Access Compliance Report

Public Rights-of-Way

Intersection ID: 46683	Main Street: GOLDFIELDS_DR	Cross Street: ABODE_LILY_LN	Location: NE
ADA ID: C5FF0CA5CB1B	Ramp Type: PerpDiag	Initial Pass/Fail: Pass	Overall Compliance: No
Severity Score: 0			
Codes/Mitigation Info/Possible Solution		Field Measurements/Component Compliance

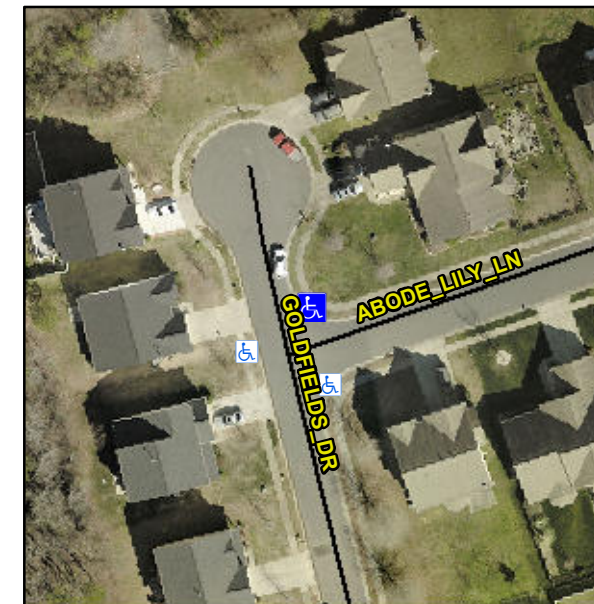
Remove & Replace Curb Ramp With Two New Directional Ramps or Equivalent.

R304.2.1, R304.2.2-Perp, R304.3.2-Para, R305.2
